***Interactive comment on* “Sensitivity of Hydrologic and Geologic Parameters on Recharge Processes in a Highly-Heterogeneous, Semi-Confined Aquifer System” by Stephen R. Maples et al.**

Received and published: 25 November 2019

Fig. 1.

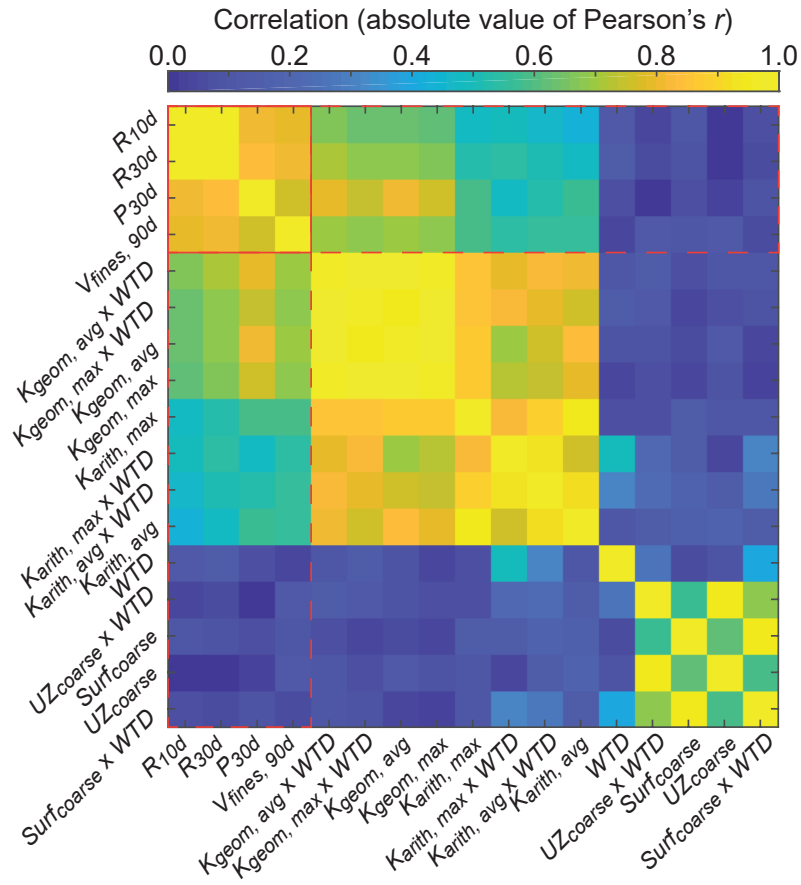
COMMENT: “Fig.1 and Fig.3 Please report the original publication source of the figure.” RESPONSE: We have reported the original source of Figure 1 (Maples et al., 2019), but Figure 3 is unique to this publication, and thus does not have a publication source, so the Figure 3 caption was left as-is.
